7 SUB2011-00066

GRAHAM HAVEN SUBDIVISION

DETAIL SITE PLAN

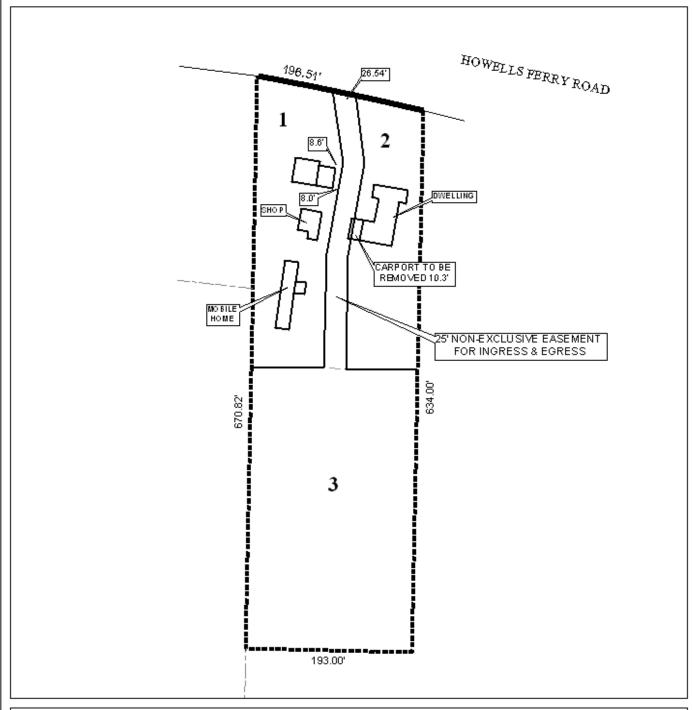
The lots appear to meet the minimum required lot sizes; however the lot sizes in square feet are not labeled on the preliminary plat. The lots should be labeled with their sizes in acres and square feet on the Final Plat, if approved, or a table should be furnished providing the same information.

It should be noted that the 25' building setback is not depicted on the preliminary plat, and if approved, should be shown on the Final Plat. The setback line for Lot 3 should be placed to be exclusive of the "pole".

As proposed, Lot 3 would be a "flag" lot with a 25'± wide, 322'± long "pole". Section V.D.1. of the Subdivision Regulations does not allow flag lots unless such are common within the area or in the case of a family division of property. The applicant submitted a letter with the application stating that the subdivision is requested in order to divide the lots among family members to settle an estate. It should be noted that approximately 1200'± to the West of the site on Howells Ferry Road that there are several "flag" lots that have been approved by the Planning Commission at its May 6, 2004 and November 5, 2009 meetings respectively. Therefore, a waiver of Section V.D.1. would be justified in this instance.

Section V.D.3. of the Subdivision Regulations states that the maximum depth of any lots, exclusive of unusable land shall not be more than 3.5 times the width at the building setback line. Using this calculation, both Lots 1 and 2 are deeper than allowed. If approved, Lots 1 and 2 will require a waiver of Section V.D.3. of the Subdivision Regulations. There are some irregularly-

The site fronts onto Howells Ferry Road, a major street with a non-compliant 80' right-of-way; therefore, a 10' dedication would be required. As a means of access management, a note should be required on the Final Plat, if approved, stating that the development is limited to one shared curb cut to Howells Ferry Road at Lot 3, with the size, location and design to be approved by County Engineering and conform to AASHTO standards.

- 1) depiction of the 25-foot minimum building setback line from Howell Ferry Road for Lots 1 & 2, as required by Section V.D.9. of the Subdivision Regulations;
- 2) depiction of the 25-foot minimum building setback line from the pole for Lot 3, as required by Section V.D.9. of the Subdivision Regulations;
- 3) the labeling of each lot with its size in square feet and acres, or placement of a table on the plat with the same information;
- 4) placement of a note on the Final Plat stating that no future subdivision of Lots 1, 2, or 3 will be allowed until adequate frontage is available;
- 5) placement of a note on the Final Plat stating that any lots which are developed commercially and adjoin residentially developed property must provide a buffer, in compliance with Section V.A.8. of the Subdivision Regulations;

6) placement of a note on the Final Plat limiting the lots to one shared curb cut to Howells Ferry Road at Lot 3, with the size, design, and location of the curb cut to be approved by Mobile County Engineering and conform to AASHTO standards;
